# HISTORIC AND DESIGN REVIEW COMMISSION

**HDRC CASE NO:** 2025-141  
**ADDRESS:** 9427 SE 410 (Previously reviewed as Approx. 9501 SE Loop 410)  
**LEGAL DESCRIPTION:** NCB 10917 P-205 (18.90 AC)  
**ZONING:** IDZ-2, H  
**CITY COUNCIL DIST.:** 3  
**DISTRICT:** Mission Historic District  
**APPLICANT:** Daniel Loss  
**OWNER:** Jim Young/SABOT DEVELOPMENT LTD  
**TYPE OF WORK:** Construction of two, 3-story, multi-family residential structures; construction of enclosed parking accessory structures; site and landscaping work  
**APPLICATION RECEIVED:** May 20, 2025  
**60-DAY REVIEW:** July 19, 2025  
**CASE MANAGER:** Edward Hall  
**REQUEST:**

The applicant is requesting a Certificate of Appropriateness for approval to construct two, 3-story, multi-family residential structures on the vacant lot at 9427 SE Loop 410. These buildings are identified as buildings 4 and 5 in the construction documents. This request also includes the installation of surface parking, enclosed parking structures, landscaping, and low-impact development features.

## Building 4 - Elevations

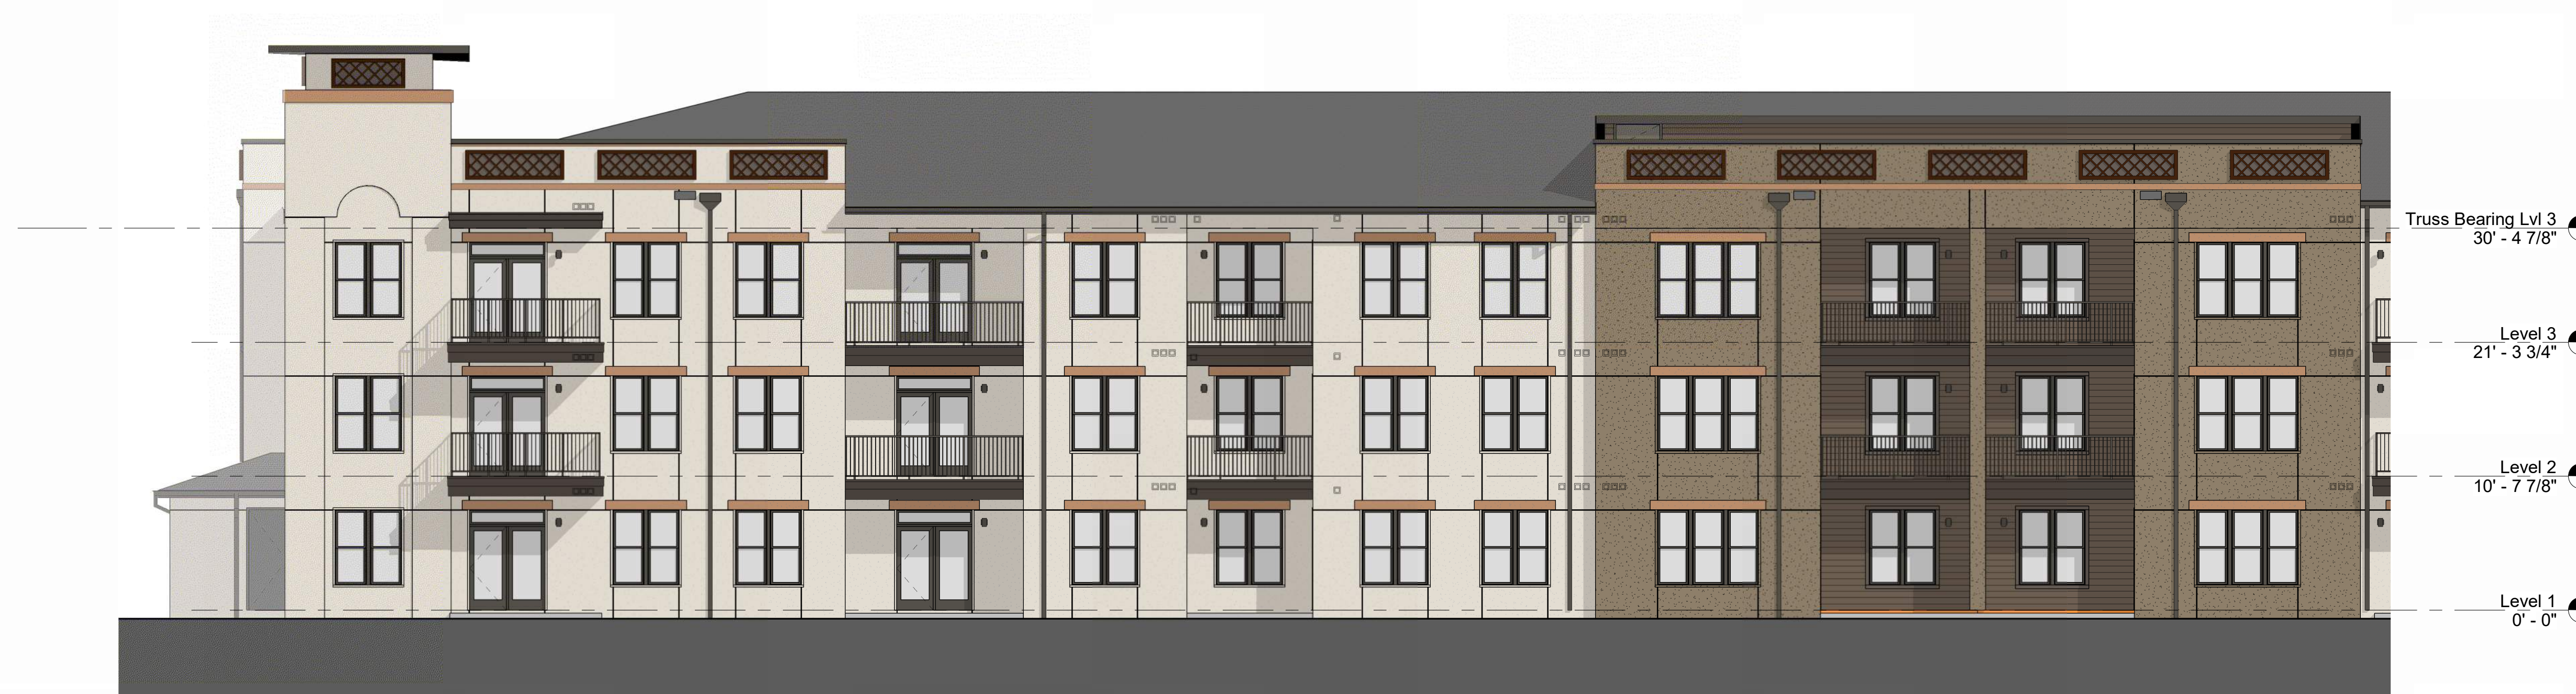
- l. FAÇADE LENGTH – The Mission Historic District Design Manual 2.B.ii. notes that commercial structures should not include uninterrupted wall planes of more than fifty (50) feet in length. Building facades may utilize an offset, substantial change in materials, or change in building height in order to articulate individual wall planes. Staff finds that the applicant has demonstrated compliance with the Mission Manual requirements for façade separation.

- q. WINDOWS – The Mission Historic District Design Manual 2.E.iii. notes that windows should be recessed into the façade by a minimum of two (2) inches and should feature profiles that are found historically within the Mission Historic District. Additionally, wood or aluminum clad wood windows are recommended. Other window materials may be appropriate provided they show consistency with staff's standard specifications for windows in new construction. The applicant has proposed to install vinyl windows and has provided detailed wall sections noting window installation at various conditions. Generally, staff finds the proposed window installation to be appropriate; however, staff finds that windows should be supplied in a dark color.
